SN J6801A-05

S E R V I C E N O T E

J6801A DNA

If it is necessary to replace the System board stack be aware there are 2 different part numbers depending on the EC revision of the unit .

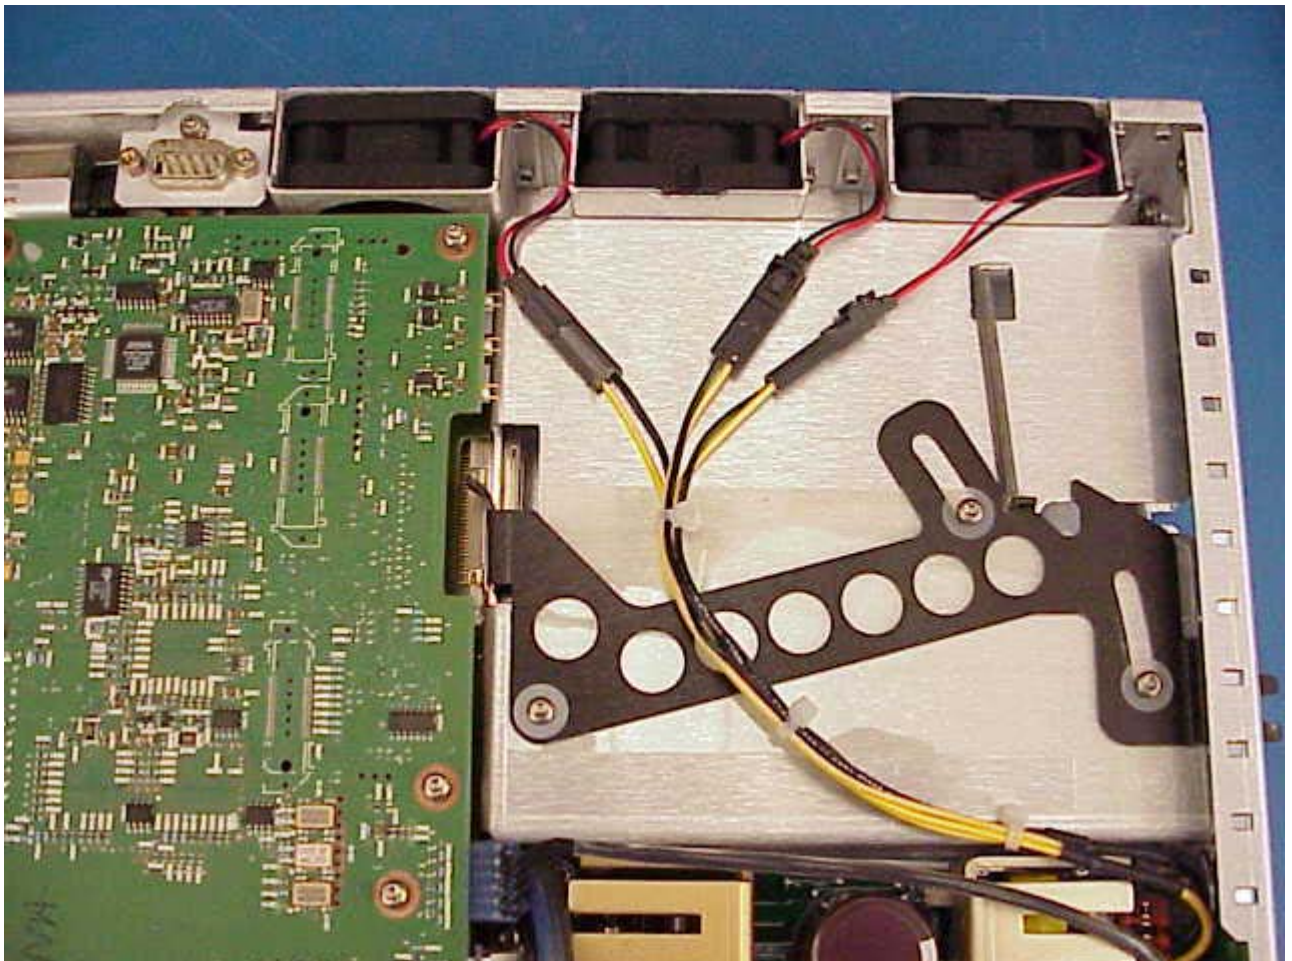
The 5065-9796 is no longer available and has been replaced by the 5067-2344. The 5067-2344 can be used to repair the J6801A of all revisions, so it is backwards compatible to the 5065-9796. HOWEVER, the 5067-0091 cannot be used to repair a unit with revision EC 13:14 or later. The new refurbished PN is 5067-2345. Note that this assembly still maintains the connectors for 5V fan operation. (See photos) 12 V fan connections for EC13:14 and beyond.

Shown here are the 5V fan connections.
